New York Telephone Co.

B599.081
~~Engineering Bulletin 444~~

PRIVATE BRANCH EXCHANGES—

#63 Induction Coil Telephone Set

FIGURE 2

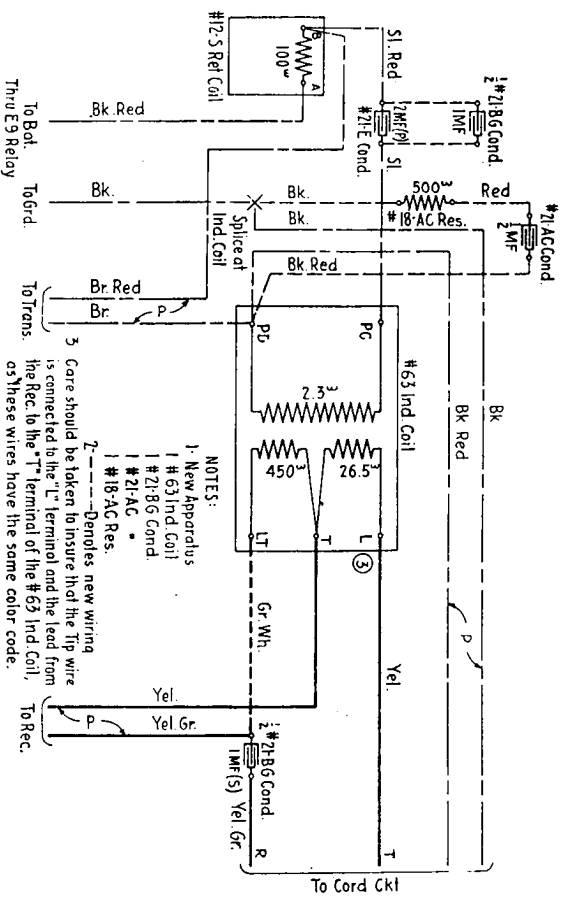
3 Care should be taken to insure that the Tip wire is connected to the "L" terminal and the lead from the Rec. to the "T" terminal of the #63 Ind. Coil, as these wires have the same color code.

- NOTES:
- 1- New Apparatus
 - 1 #63 Ind. Coil
 - 1 #21-BG Cond.
 - 1 #21-AC
 - 1 #18-AC Res.

2- --- Denotes new wiring

FIGURE 3

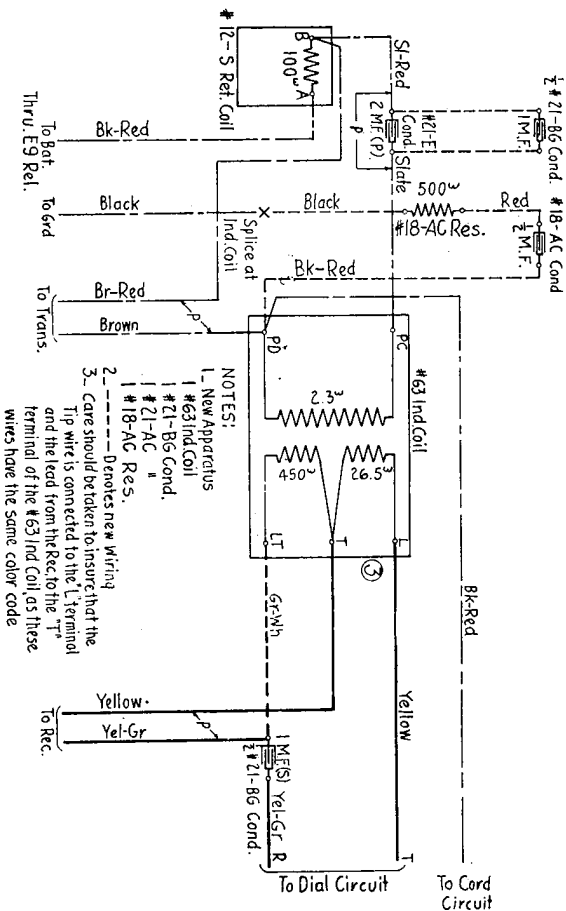
※ 550-C P. B. X. SWITCHBOARD WIRED PER CIRCUIT PASTER P-162190
 Method of Rewiring Attendant's Telephone Set Circuit Using ※ 63 Induction Coil

FIGURE 4

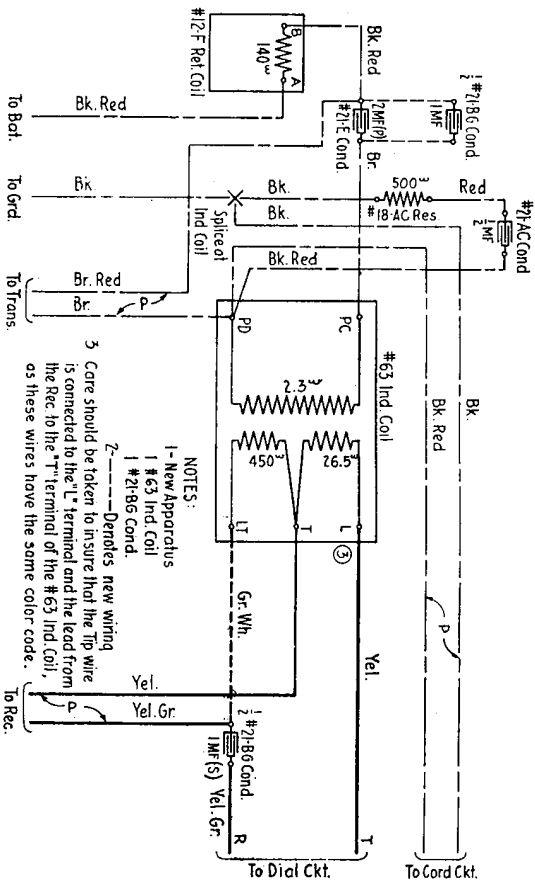
3 Care should be taken to insure that the Tip wire is connected to the "L" terminal and the lead from the Rec. to the "T" terminal of the #63 Ind. Coil, as these wires have the same color code.

- NOTES:
- 1-New Apparatus
 - 1 #63 Ind. Coil
 - 1 #21-B6 Cond.

Z-----Denotes new wiring

FIGURE 5

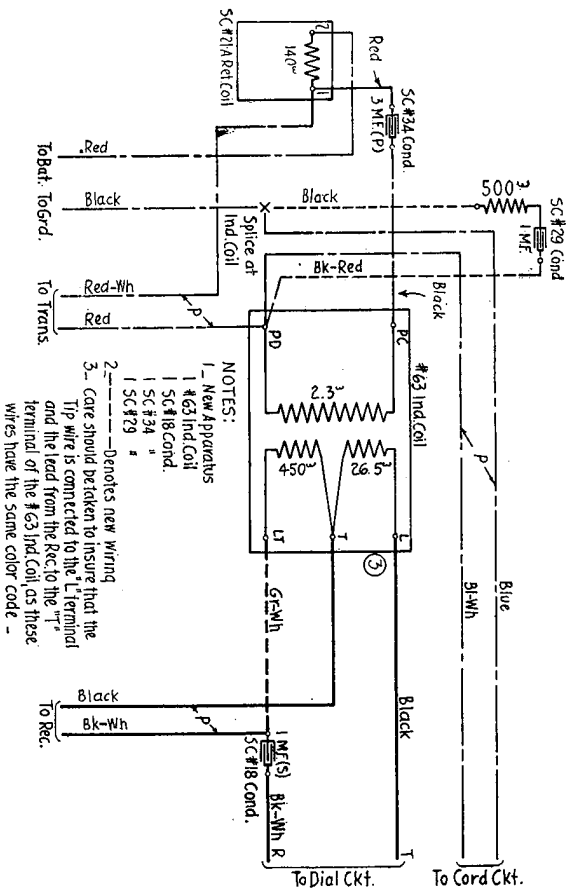
* 550-SC P. B. X. SWITCHBOARD WIRED PER CIRCUIT PASTER FORM * 948
Method of Rewiring Attendant's Telephone Set Circuit Using * 63 Induction Coil

FIGURE 6

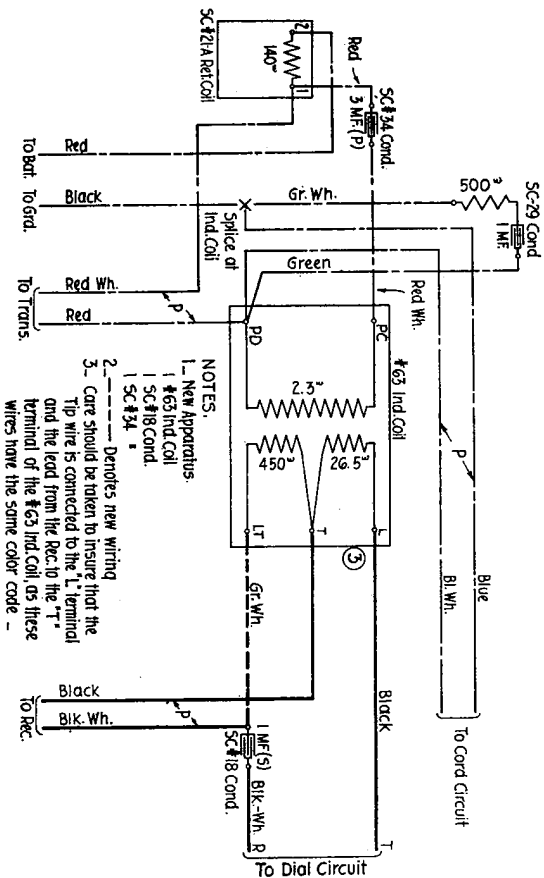
※ 550-SC P. B. X. SWITCHBOARD WIRED PER CIRCUIT PASTER FORMS ※ 967 and ※ 1078
 Method of Rewiring Attendant's Telephone Set Circuit Using ※ 63 Induction Coil
